Robatel Technologies, LLC RT-100 RAI Meeting June 19, 2013

RAI Dated March 28, 2013
TAC No. L24686
Docket No. 71-9365

- ▶ **RT-100 Certification Process Overview**
 - Submitted CoC Application No. 9365 October 9, 2012 for Type B radioactive waste transport cask – RT-100
 - Received NRC RAI request dated March 28, 2013
 - 63 items to answer and/or clarify
 - Met with NRC on April 17, 2013 for early review of several RAI comments
 - Two meetings to review RT's interpretation and path forward for NRC RAI
 - June 18 – Materials & Structural
 - June 19 – Thermal, Containment & Shielding
 - Time permitting, review other RAI responses
 - Proposed approach and strategy for resolution

Explain the inconsistency in the times to reach the maximum lead temperature for the side impact fire accident in Figure 3.4.2.2–3, and the maximum O–ring seal temperature for the top impact fire accident in Figure 3.4.2.2–6.

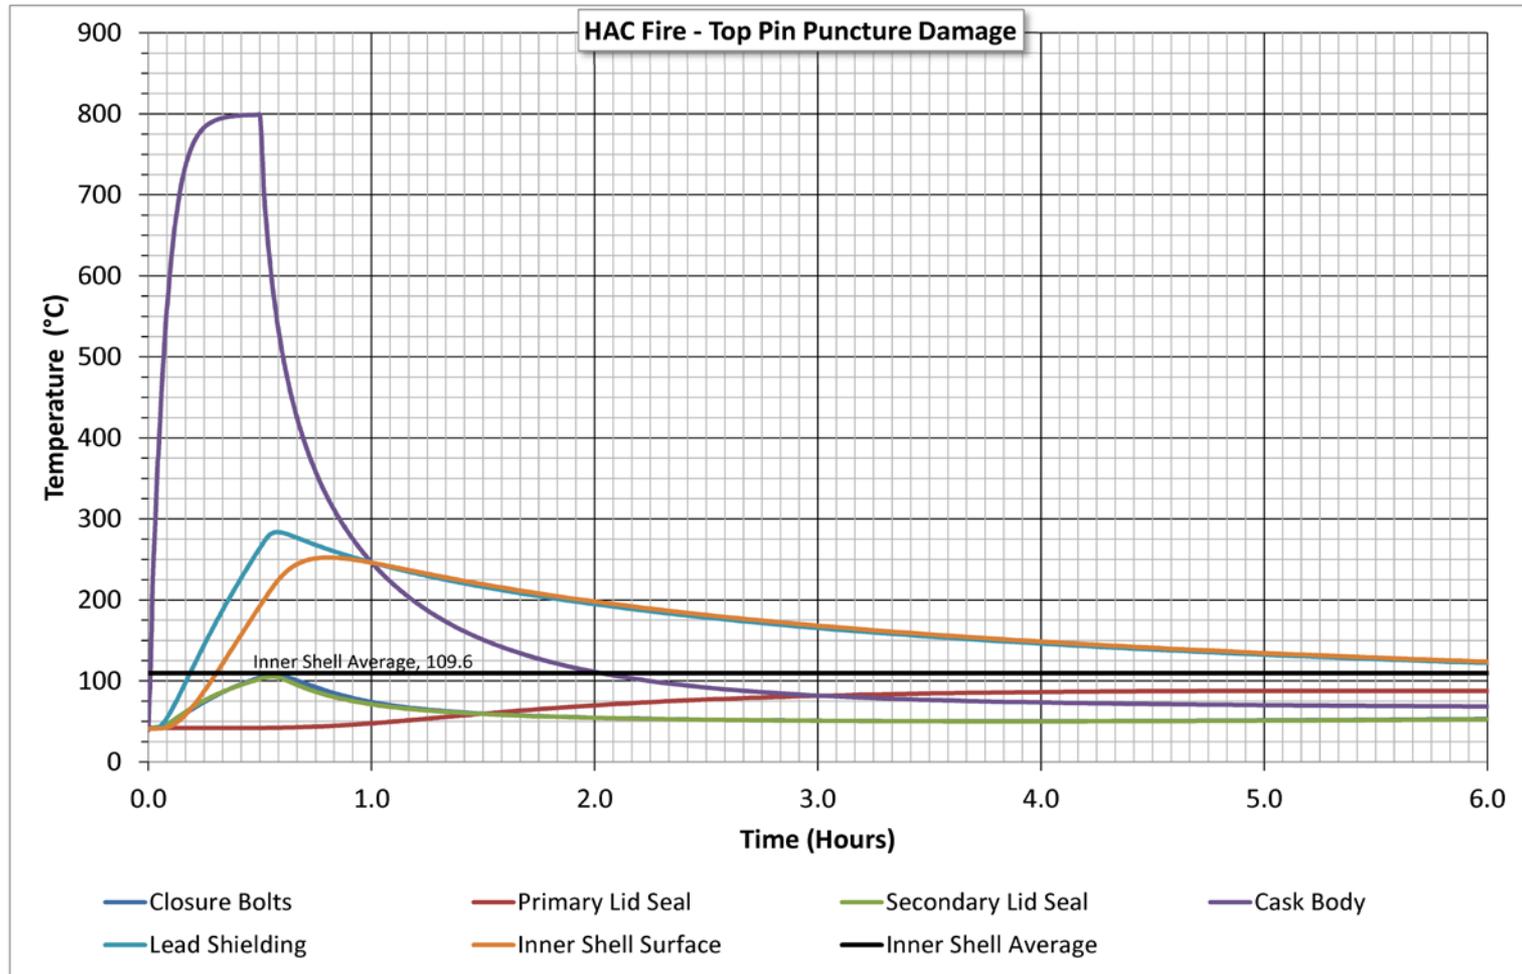
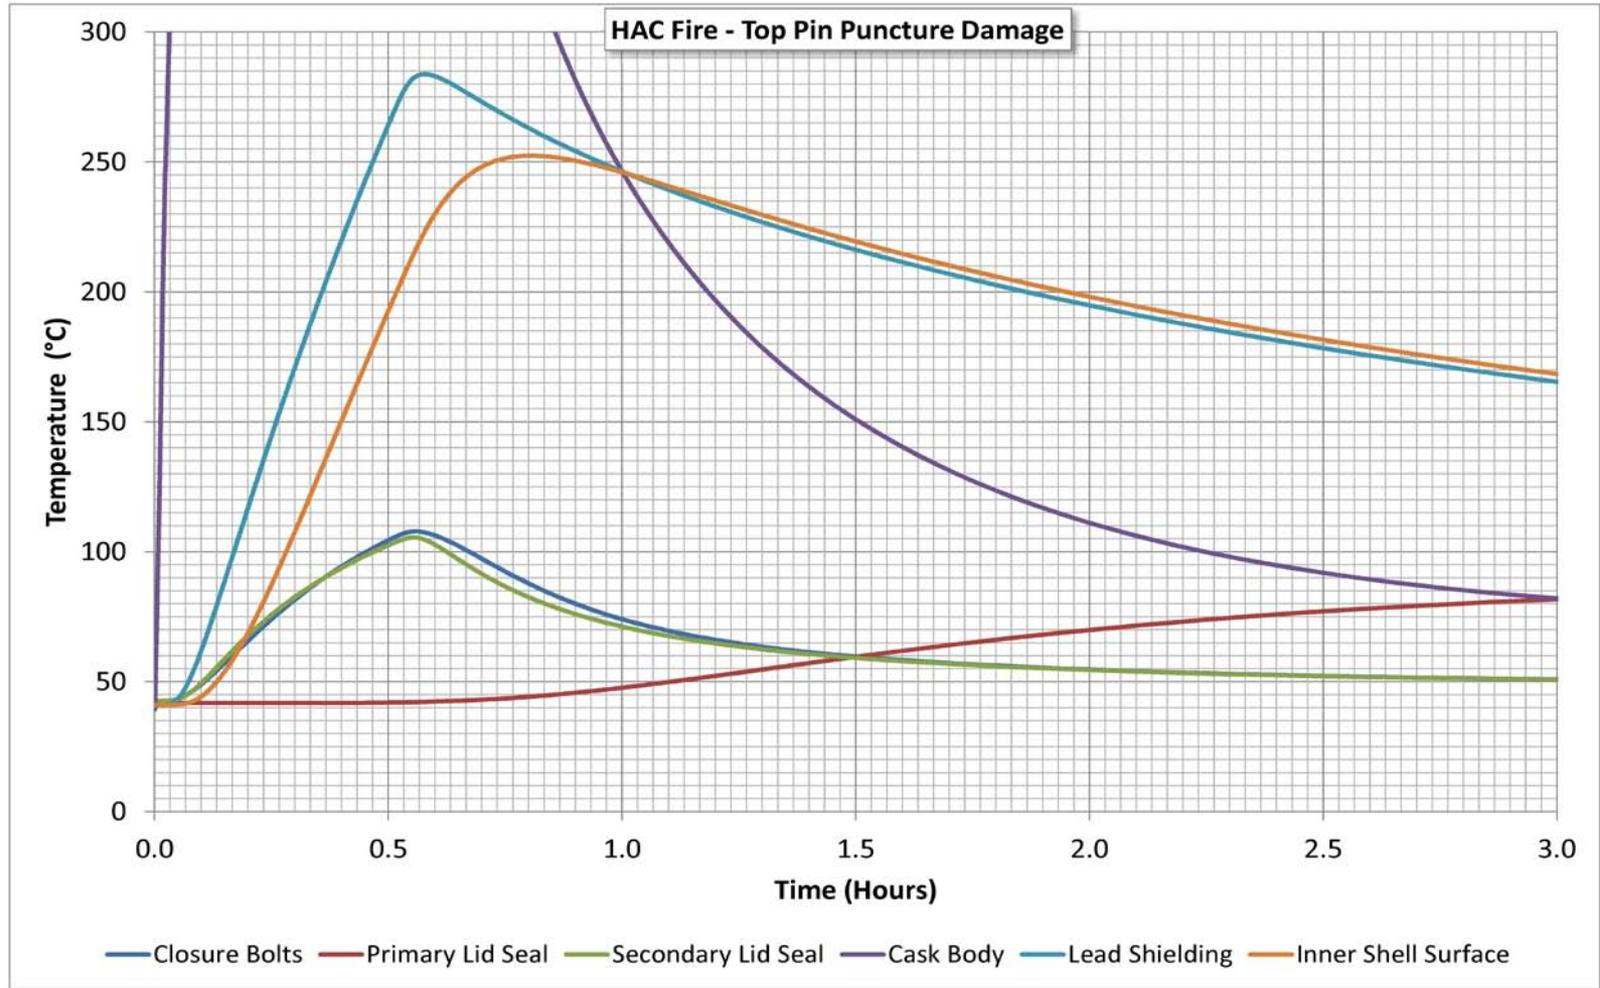
- a) The applicant showed a time of 2077 seconds, which projects to ≈ 1830 seconds in the X Coordinate of Figure 3.4.2.2–3 (Close–up View), to reach the maximum lead temperature under the side impact fire accident.
- b) The applicant also showed a time of 1957 seconds, which projects to ≈ 2160 seconds in the X Coordinate of Figure 3.4.2.2–6 (Close–up View), to reach the maximum O–ring seal temperature under the top impact fire accident.

The applicant should clarify this inconsistency, as mentioned in a) and b) above. The applicant should plot the temperature history starting from 0 minute (into the fire) to 300 minutes in the close–up views of Figures 3.4.2.2–3 and 3.4.2.2–6.

- ▶ The thermal analysis for the HAC fire accident and post-fire cool-down has been revised as result of other RAI regarding Chapter 3
- ▶ As a result, the figures presenting the time history of the lead and O-ring seal temperatures will be revised to present the updated temperature history values
- ▶ Additionally, the format has been updated to allow the time in the figures to be presented in a clearer manner
- ▶ The revised figures clearly show the time along the x-axis of each figure starting with the beginning of the fire as time = 0 seconds, allowing the reader to verify the time at which the maximum temperatures occur
 - [Examples shown on the following slides](#)
